Re: MCB Camp Lejeune; Responses to EPA Region IV Comments on
the Draft Final RI/FS Project Plans for Operable Unit #5
(Site 2)

Response to Comments
Navy and Marine Corps Response to EPA Region IV Comments on the
Draft Final RI/FS Project Plans for Operable Unit #5, MCB Camp
Lejeune, received via letter dated 11 February 1993

Figure 2-4 *PRELIMINARY*
GROUND WATER CONTOUR MAP—
SHALLOW AQUIFER, SITE 2—
FORMER NURSERY/DAY CARE CENTER

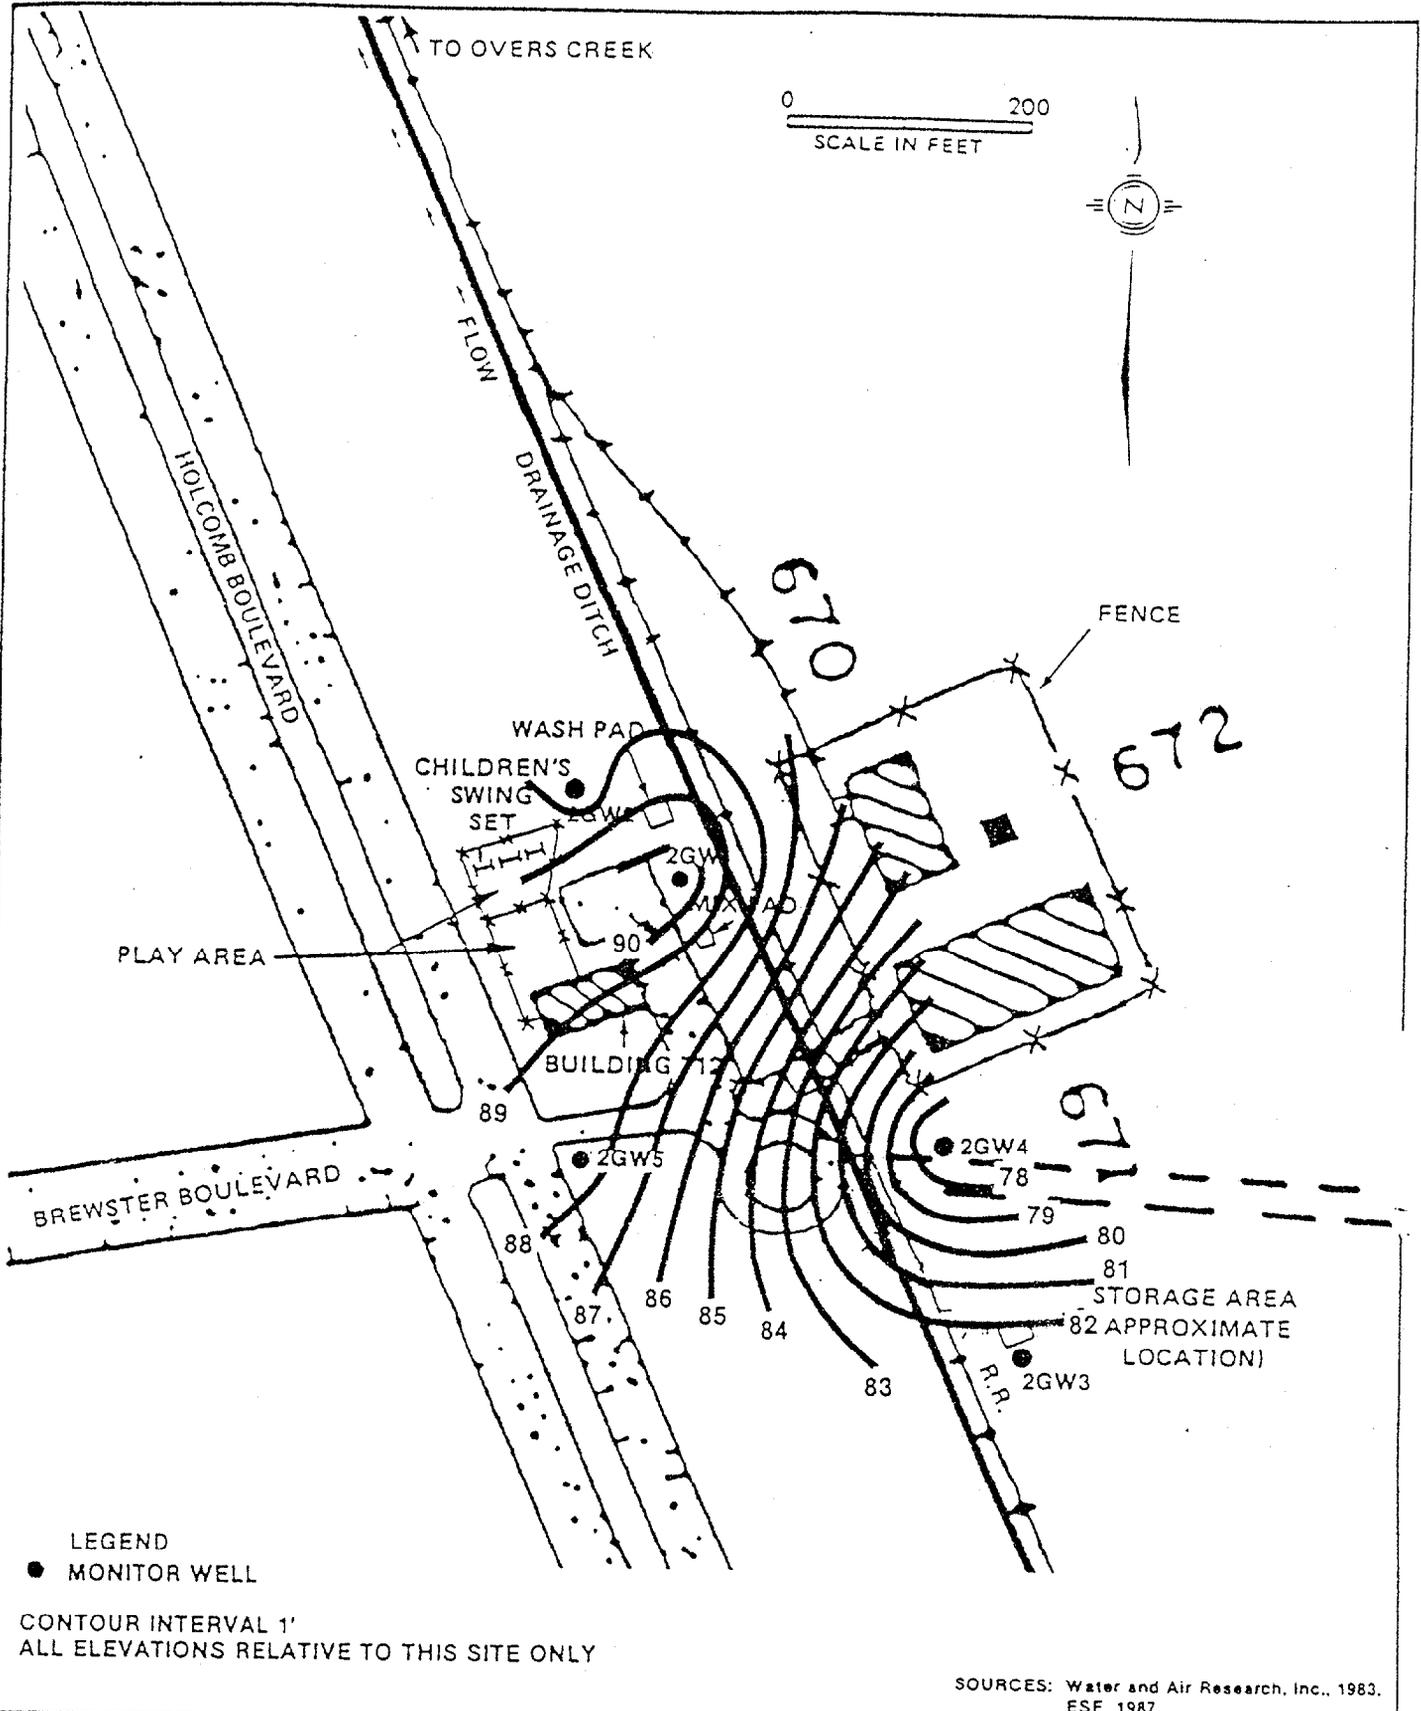
3. Attached to this response summary is a preliminary groundwater contour map. This figure was developed using only one round of groundwater elevations. Groundwater flow direction at Site 2 is reportedly southeast, based on this one round of static water level measurements. Groundwater flow direction needs further evaluation prior to developing final groundwater contour maps. Water level measurements for the site monitoring wells will be recorded periodically during the field investigation phase of the RI. Final Groundwater contour maps will be included in the RI report.
